UNITED STATES PATENT AND TRADEMARK OFFICE

APPLICATION NO.	FILING DATE	FIRST NAMED INVENTOR	ATTORNEY DOCKET NO.	CONFIRMATION NO.
10/828,939	04/21/2004	William R. Siskos	1930A1	7209

Office Action Summary

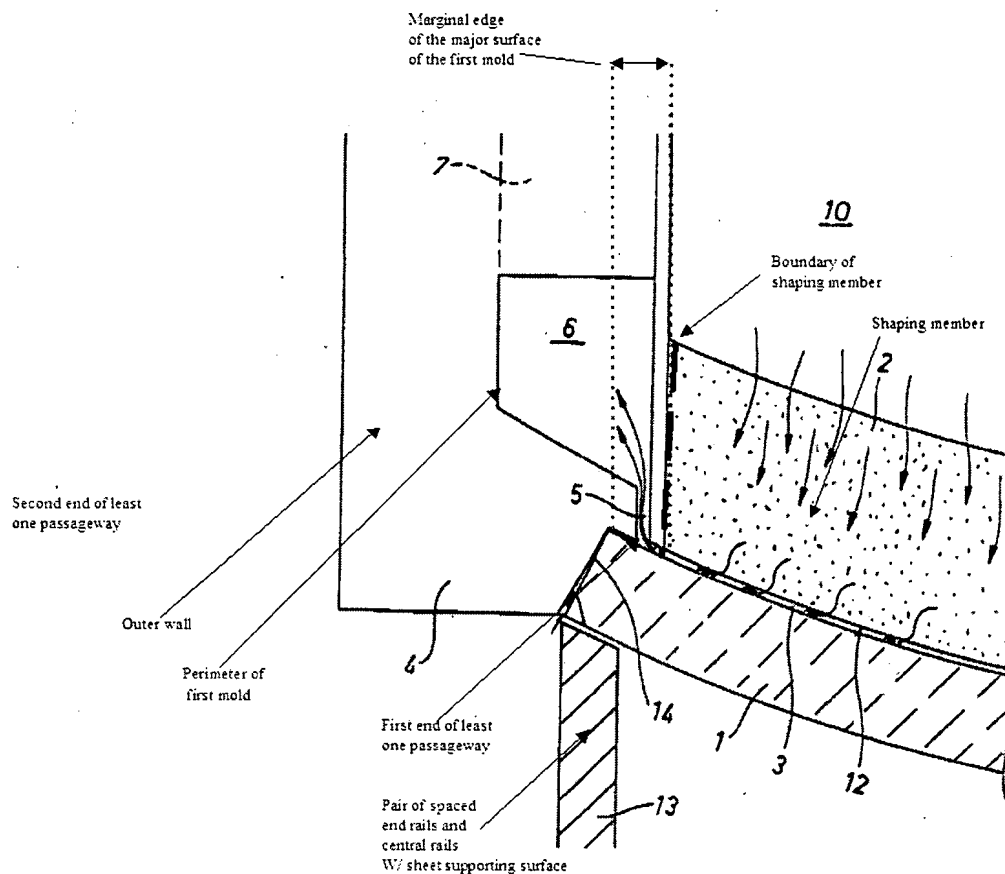
With respect to the apparatus set forth in applicants claim 1, Montonen teaches a ring mold (13) or second mold comprising a pair of spaced end rails and central rails with an I shaped cross section [**Claim 12**] and presenting a continuous sheet supporting surface [**claim 2**]. An upper first mold comprises a central shaping member (2) having a peripheral boundary, an outer wall (4) securely mounted to the first mold defining an "perimeter of the first mold" [**Claim 4**], and "a marginal edge" located between the boundary of the shaping member and the perimeter of the first mold. "At least one passageway" (5) has a "first end" located in the marginal edge of "a major surface of the first mold" which faces the second mold.

It is evident from the above figure 2 that near a closest approach between the upper and lower molds, the outer wall forms an enclosure with said first and second molds wherein the outer wall is "mounted to" the second mold, surrounding the central rails and end rails [**Claim 6**]. The outer wall of the first mold has one part of an *aligning arrangement* [**Claim 7**] (e.g. surface angled from vertical) which cooperates with an aligning arrangement of the second mold (eg. the rails) as claimed. Although Montonen is silent regarding the claimed elevator arrangement, such an arrangement is either deemed an integral and implicit component of the disclosed apparatus or alternatively would be considered a trivial modification over the disclosed apparatus by one of ordinary skill in the art at the time of the invention. Specifically, Montonen

Fig. 9

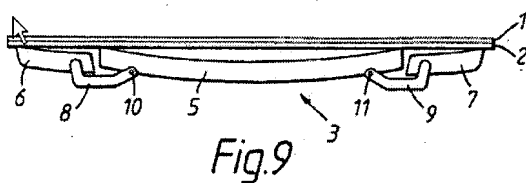
a generally horizontal support for a sheet to a second position where portions of the ends of the end rails are raised above the central rails. Jacques presents a ring mold having movable ends providing said first generally horizontal support (Fig 9) and said second raised configuration (Fig 11) to achieve deep and/or complex bent shapes (Abstract).

It would therefore have been obvious to one of ordinary skill in the art at the time of the invention seeking to achieve a deep bend in a glass sheet to utilize the reconfigurable ring mold as taught by Jacques in the sheet molding system taught by Montonen.

FIG. 5

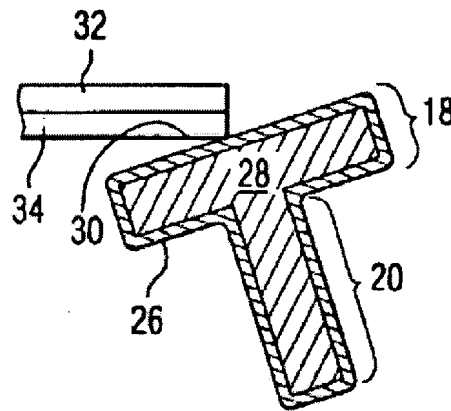
With respect to **Claim 8**, Montonen teaches that the central and end rails have a "I" shaped cross section (as evidenced in the Fig 2 excerpt above) while failing explicitly set forth that they may be constructed with a "T" shaped cross section as claimed. Skeen teaches (Column 2, Lines 3-6) that glass bending ring mold "rails themselves are usually pre-shaped to have a shape to support the unbent sheet while also supplying the mold for the curved or bent sheets" and that (see Fig 5 excerpt and Column 2, Lines

36-39) "the rail member itself may be a bar member that supports the glass sheets slightly inboard of the glass sheets periphery or it may be an "L" or "T" shaped member." It would have been obvious to one of ordinary skill in the art at the time of the invention to modify the central and end rails of the Montonen process to utilize a "T" shaped member as taught by Skeen. This would have been an obvious modification to one seeking to provide adequate support to both an unbent and bent glass sheet.

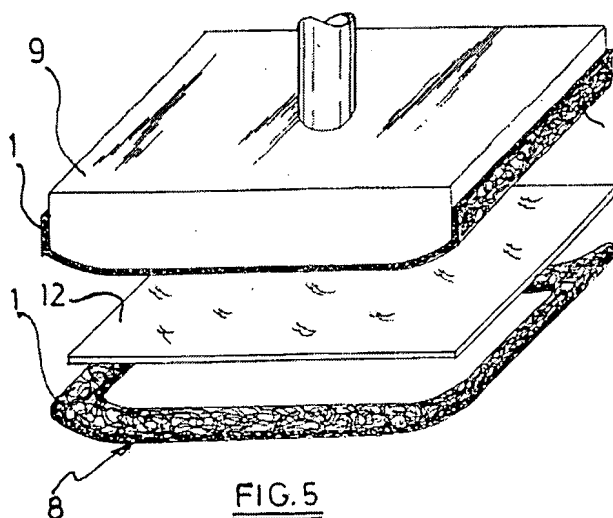
Montonen teaches a continuous groove or "slotted annular structure" which emerges in the marginal region of the major surface of the first mold but remains silent regarding the presence of a plurality of holes in said marginal region. Posney teaches a structured mold having an apertured wall contoured to the desired shape of the bent glass sheet and having elongated, shallow grooves and a row of apertures contained therein for delivery of fluid under pressure to the surface of the glass sheet. With respect to the structure of the mold surface, Posney clearly sets forth that the aperture structure in the disclosed mold is "less fragile than molds slotted throughout their entire thickness" (Column 2, Lines 63-69).

Where the peripheral annular groove of the Montonen mold is understood to embody a structure "slotted through the entire thickness", it would have been obvious to adopt the aperture structure taught by Posney. Restated, it would have been an obvious modification to replace the peripheral annular groove of Montonen with a "first plurality of passageways as taught by Posney. The modification of the Montonen structure to include holes or apertures within the annular groove would have been an obvious alteration to one of ordinary skill in the art at the time of the invention seeking to make the mold structure less fragile as taught by Posney.

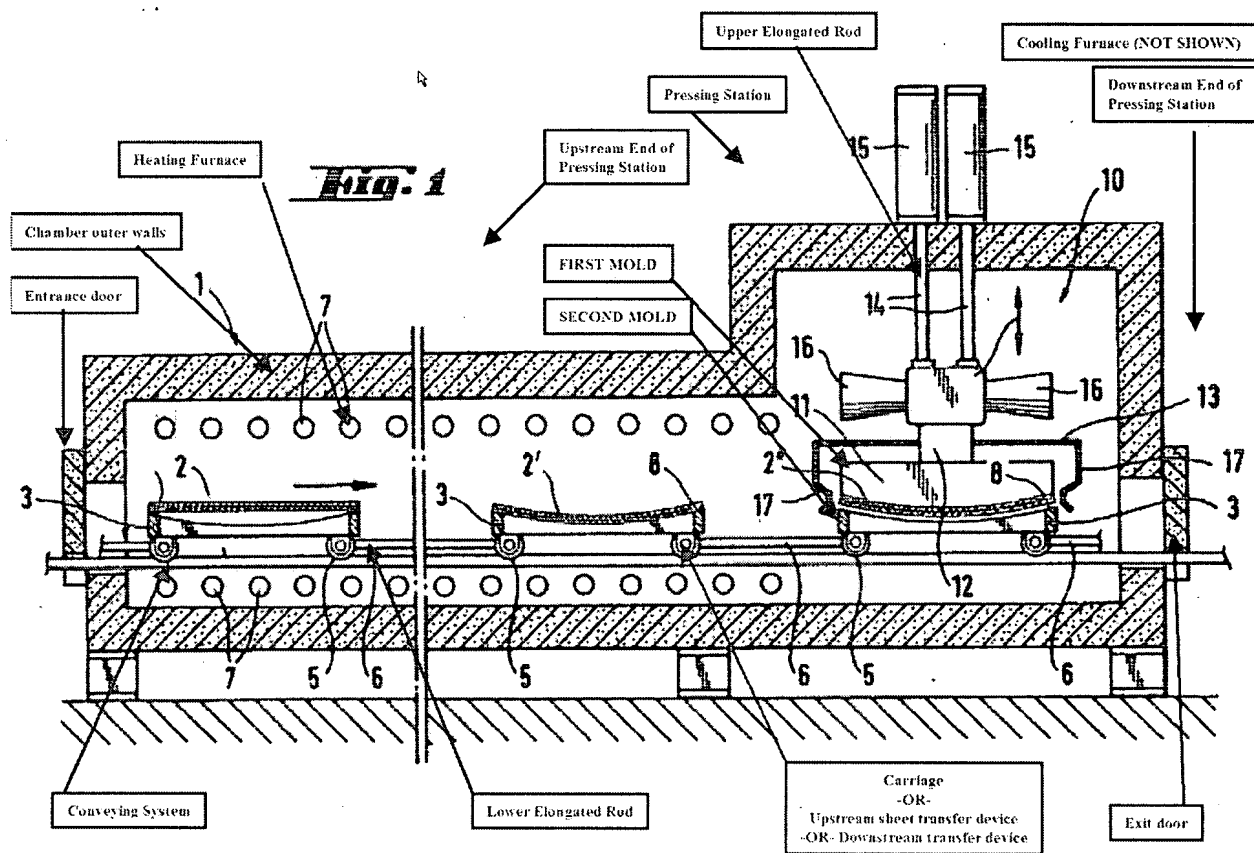
As indicated above, Montonen discloses essentially every element of Applicants claimed bending apparatus, however the instant reference remains silent regarding the details of the broader pressing station. As indicated to Applicant in previous Office Actions, the Kuster reference teaches a sheet bending apparatus comprising a concave

Kuster further teaches the integration of the mold arrangement into the furnace and pressing station. Specifically, the following excerpt Figure 1 from the Kuster reference has been edited with examiners annotations in order to assist correlation of prior art teachings with applicants claimed elements in applicants chosen lexicon. Details of the operation are also set forth in the immediate reference Column 3, line 56 through Column 4, line 49.
